RE: The Arbors Subdivision – Alternate Street Standard

**Review Comments**  
**The Arbors Sub. – Alt. Street Standard**

**PP-2005-105**

RE: The Arbors Subdivision TEDS Exception (Design Exception #DE 24-05)

TYPICAL ALLEY SECTION F-F

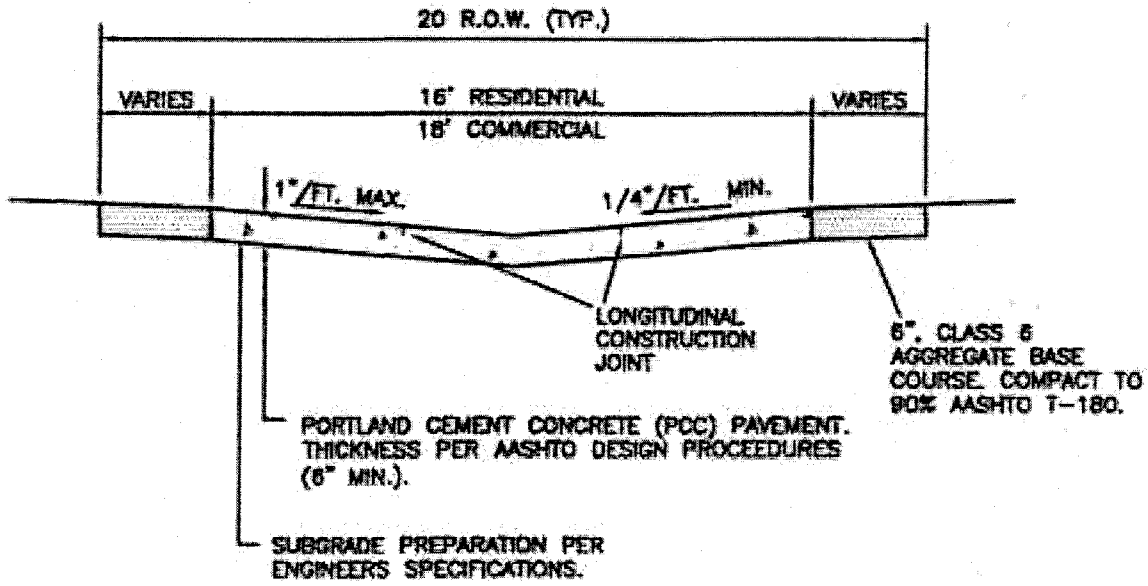
**The Committee did not approve the request to modify the standard concrete alley section.** The group did mention they would be willing to review a life cycle cost analysis for the asphalt/concrete section you proposed and contrast it with the standard concrete section. If you want to explore this option in more detail, just give me a call.

As mentioned in the TEDS Exception Committee letter dated December 2, 2005 (enclosed) the committee would be willing to review a life cycle cost analysis for the asphalt/concrete alleyway sections proposed for the Arbors Subdivision.

I assumed that the alleyway width is 16 feet (Residential Alleyway section) for both the concrete and the asphalt sections (see enclosed typical sections) and that the underlying subgrade and preparation was the same for both sections. I assumed an annual discount rate of 5% for the duration of the analysis and I assumed that the asphalt alleys would be milled and receive a 1" overlay applied every 4 years. It is assumed that the concrete alleyway will have be replaced at 20 years. These assumptions are based upon information from city staff as well as local experience in the design of residential subdivisions.

The proposed asphalt alleyway structural section is adequate for 160,000 ESAL's as indicated in the letter dated January 10, 2006 from Huddleston-Berry (enclosed). It should be noted that the same pavement section proposed for the alleyways shall be installed on the subdivision roadways. The alleyway section also features a 3 ft concrete v-pan to prevent damage from storm water damage.

The proposed asphalt alleyways can be expected to perform adequately given the assumptions above. I request that the committee review the attached life cycle cost analysis and approve the alternative alleyway sections proposed for the Arbors Subdivision.
